D3290-041 REPLACEMENT WINDOW ASSEMBLY

| DRAWING NO. D3290 | TITLE REPLACEMENT WINDOW ASSEMBLY | REV. C | DART AEROSPACE LTD ENGINEERING ORDER | | D.E.O. NO. D3290-C-1 | SHEET NO. SHEET 1 OF 1 | SCALE NTS |

PURPOSE:

CHANGE MATERIAL THICKNESS OF D3290-1 FRAME TO 0.063 FROM 0.040. REF PAR 09-033.

D3290-1 FRAME

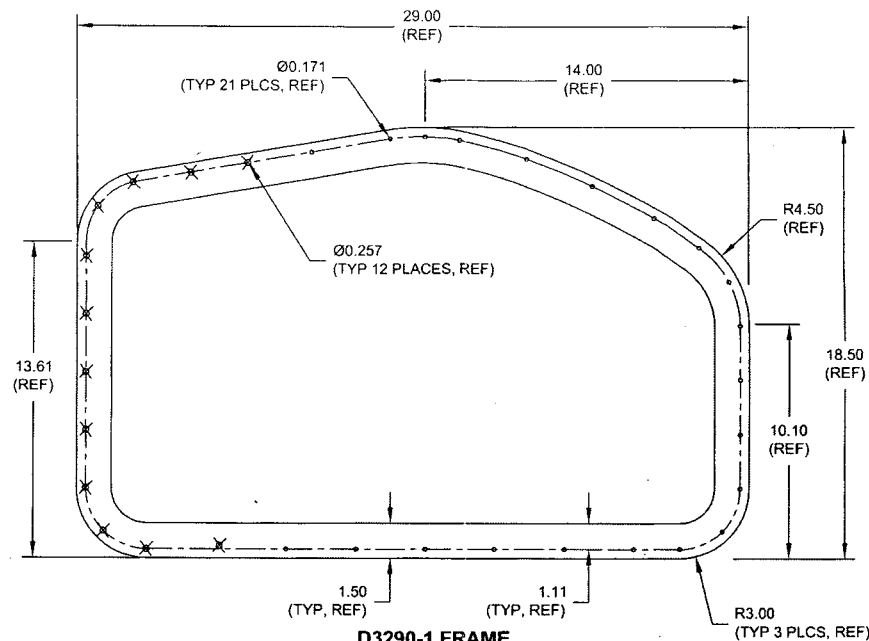
MATERIAL CALL-OUT OF D3290-1 FRAME ON SHEET 1 IS AMENDED AS FOLLOWS:

- 1) MATERIAL: 6061-T6 (OR 6061-T62) ALUMINUM SHEET ~~0.040 THICK~~ 0.063 THICK (REPLACE)
 PER AMS-QQ-A-250/11 OR AMS 4025 OR AMS 4027
~~(REF. DART SPEC. M6061T6S.040)~~ REF. DART SPEC. M6061T6S.063 (REPLACE)
 OR
 5052-H32 ALUMINUM SHEET ~~0.040 THICK~~ 0.063 THICK (REPLACE)
 PER AMS-QQ-A-250/8 OR AMS 4016
~~(REF. DART SPEC. M5052H32S.040)~~ REF. DART SPEC. M5052H32S.063 (REPLACE)
